APPEAL SUMMARY

Appeal ID: 15731	Project Address: 535 NW 11th Ave
Hearing Date: 8/23/17	Appellant Name: Tom Jaleski
Case No.: B-016	Appellant Phone: 9712385266
Appeal Type: Building	Plans Examiner/Inspector: Jerry Englehardt
Project Type: commercial	Stories: 14 Occupancy: R-2, S-2, M Construction Type: I-A
Building/Business Name:	Fire Sprinklers: Yes - throughout
Appeal Involves: Reconsideration of appeal	LUR or Permit Application No.:
Plan Submitted Option: pdf [File 1]	Proposed use: Residential, parking, retail

Appeal item 1

ENLARGED FLOOR
PLAN - TYPICAL LEVEL

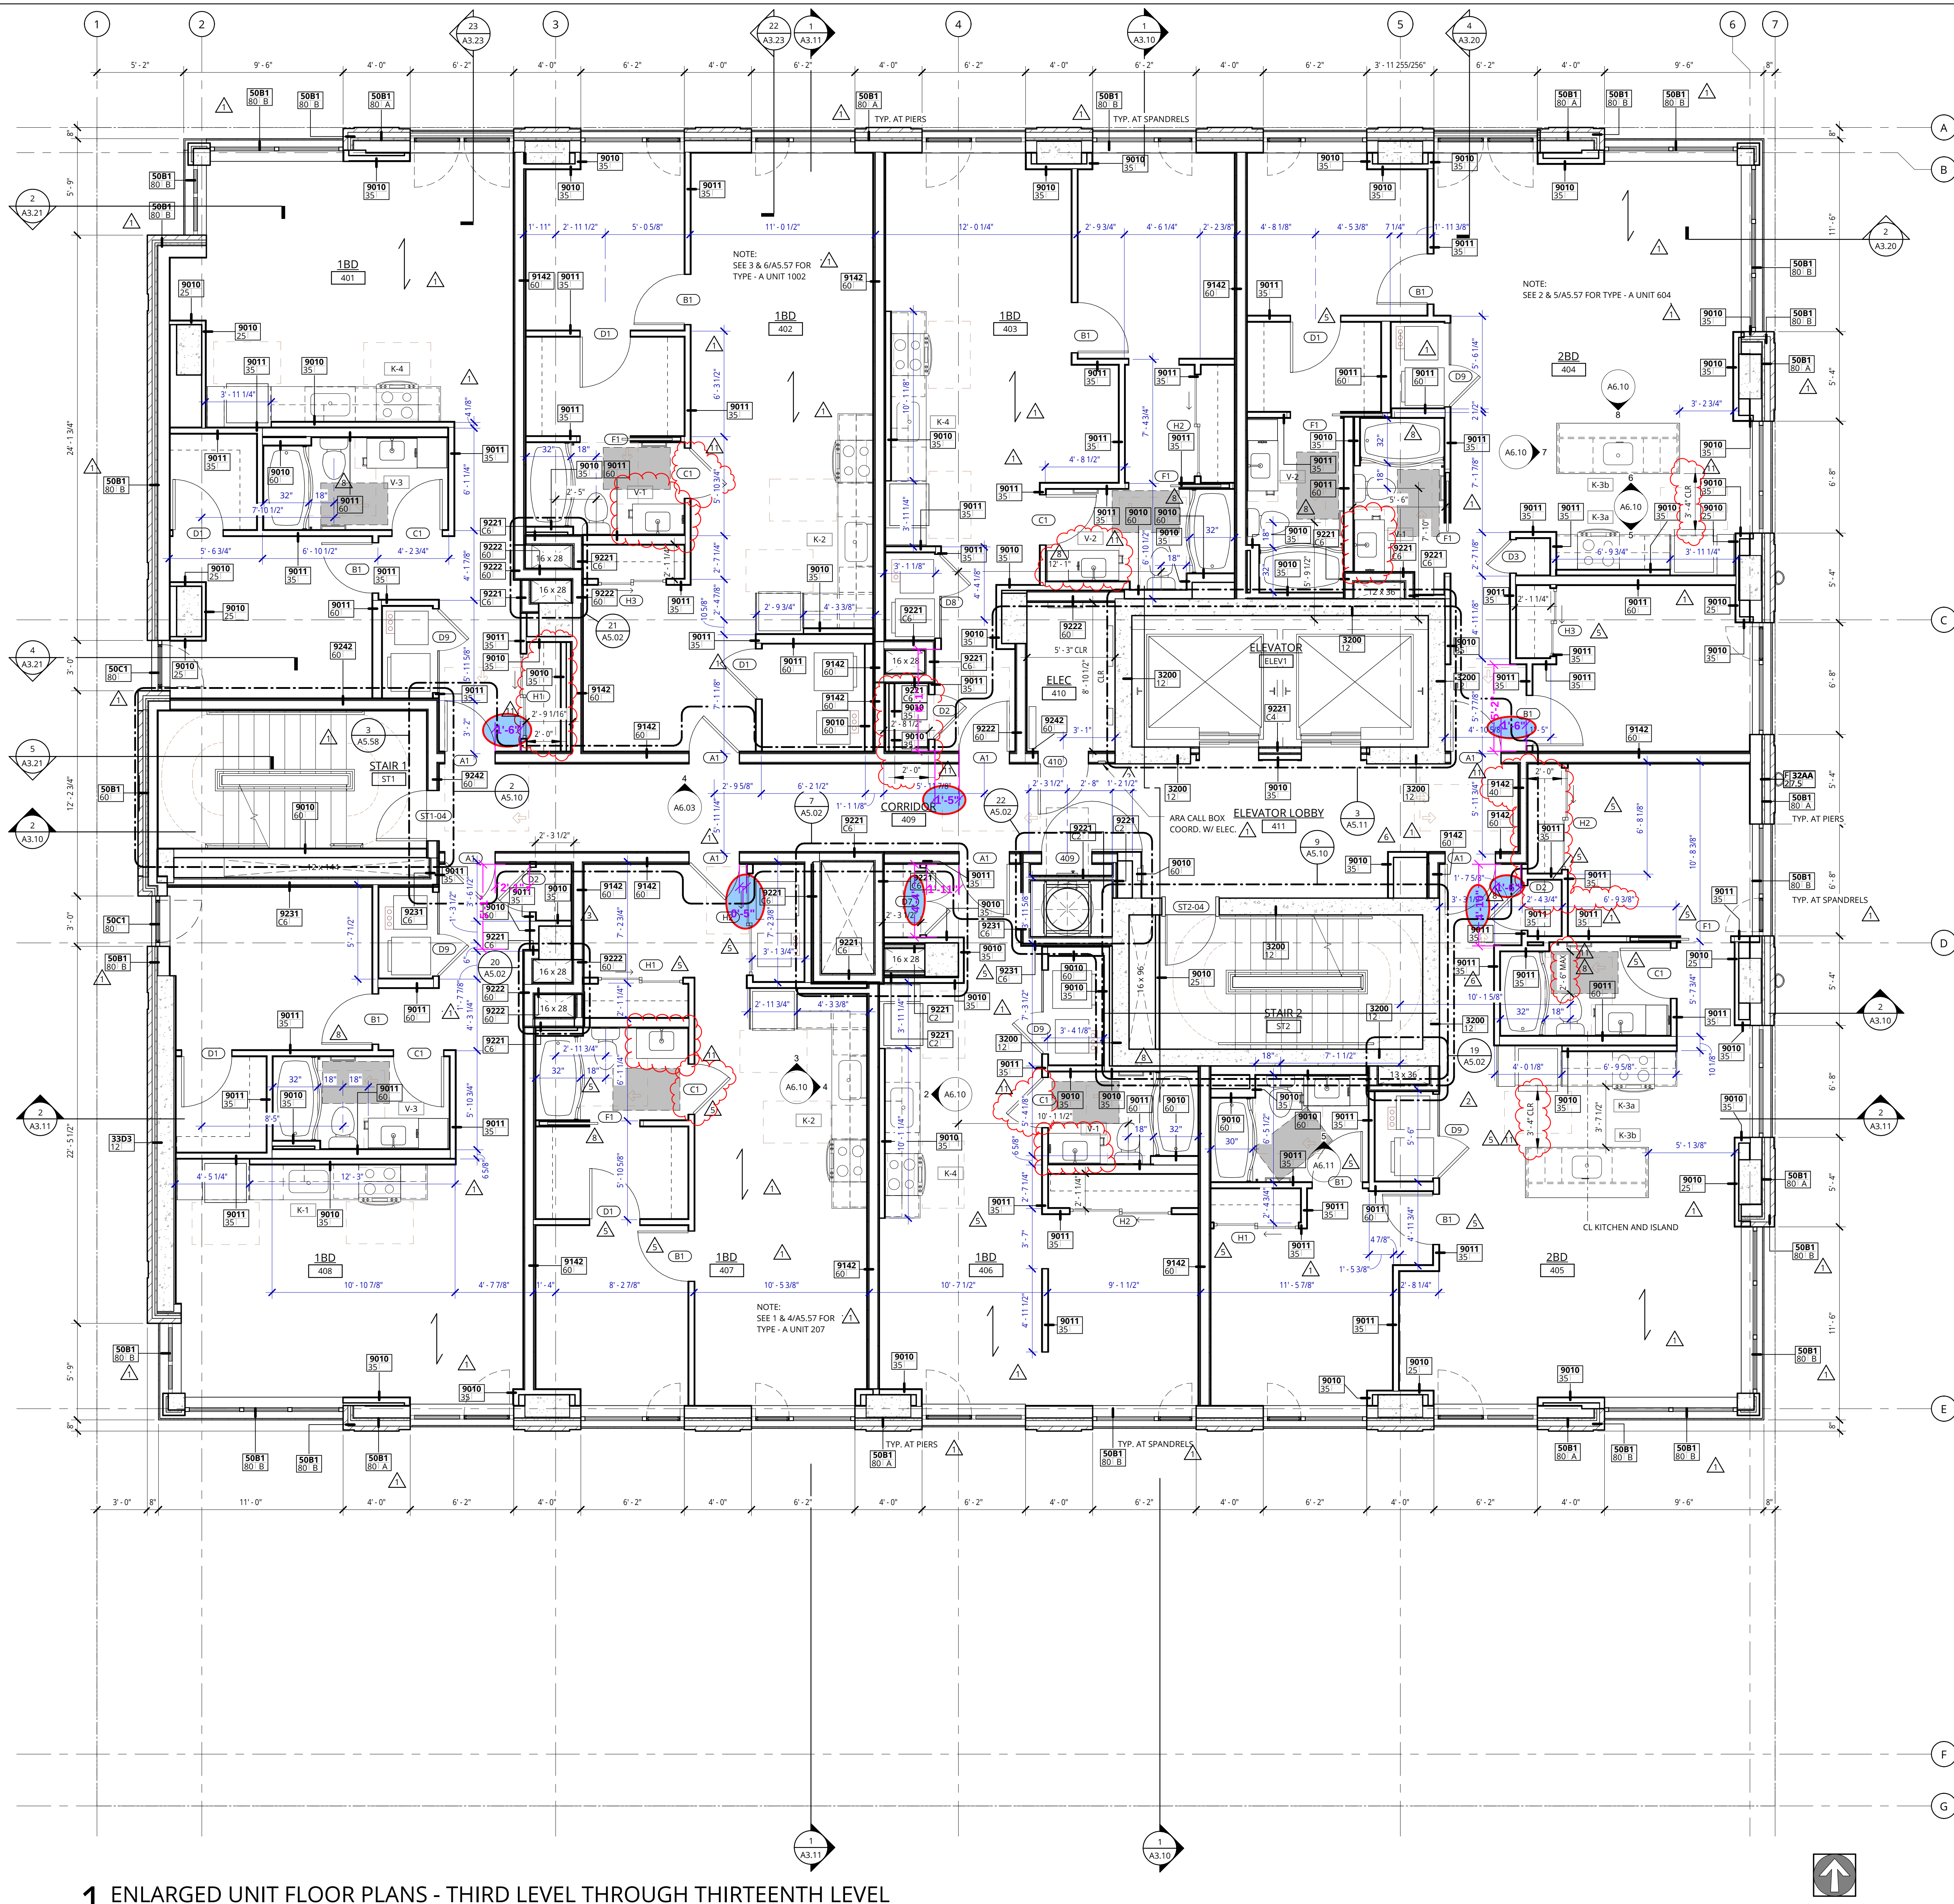
Reason for alternative	The proposed design follows ORS 447.220 that states that covered multifamily dwellings shall be accessible to and usable by all persons with disabilities, as provided in the Fair Housing Act. The Fair Housing Act uses a design manual called the Fair Housing Act Design Manual that provides guidelines on Usable Kitchens, Bathrooms and Doors, as well as routes and spaces. The Fair Housing Act has acknowledged that the 2003 ICC A117.1 is a safe harbor document for compliance to the federal requirements of the Fair Housing Act. Both the Fair Housing Act Design

Manual and the 2003 A117.1 specifically exempt door maneuvering clearance requirements on the interior side of the primary entrance door into a Type B unit.

The use of Type B units meets the requirements of ORS 447.220 and federal FHA standards, therefore provides equivalent accessibility.

Type B residential units with maneuvering clearance on interior side of primary entrance door per 1988 Fair Housing Act Design Manual: Denied. Proposal does not provide equivalent accessability.
